AN ADDITION TO WICHITA, SEDGWICK COUNTY, KANSAS

Re: S/D 91-43 (Final Plat) Fire Station 16 Addition

STAFF REPORT
(Final Plat Approved 9/19/91)

CASE NUMBER: S/D 91-43 - FIRE STATION 16 ADDITION

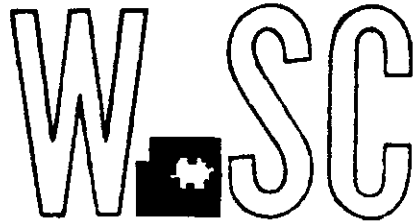
- E. On the final plat tracing, the face of the plat shall delete the word "complete" from the access control shown to Tyler Road. One opening to the northern lot and two openings to the southern lot may be indicated. Since complete access control is being dedicated to Robin, the platting's text shall also note this dedication.

- F. On the final plat tracing, 16th Street North and the indicated right-of-way shall be properly indicated. The position of the center line (C/L) of 16th Street North should be properly located and shown with a 32-foot half-street right-of-way or, if all of the street's right-of-way is shown, the C/L should be deleted and the street name centered within the 64-foot right-of-way.
